## ATTACHMENT C

### Proposed draft rule following AEMO 2022-23 review of the technical requirements for connection

**Figure S5.2.1**

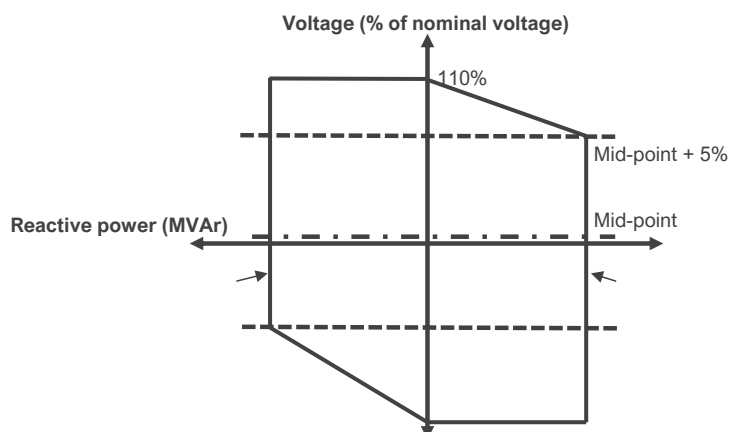
~~(ii) absorbing an amount at least equal to the amount specified under sub-paragraph (i) at the lower limit of the voltage range in paragraph (1), decreasing linearly to zero at the lower limit established under clause S5.1a.4 without a contingency event,~~

~~as illustrated in Figure S5.2.1.~~
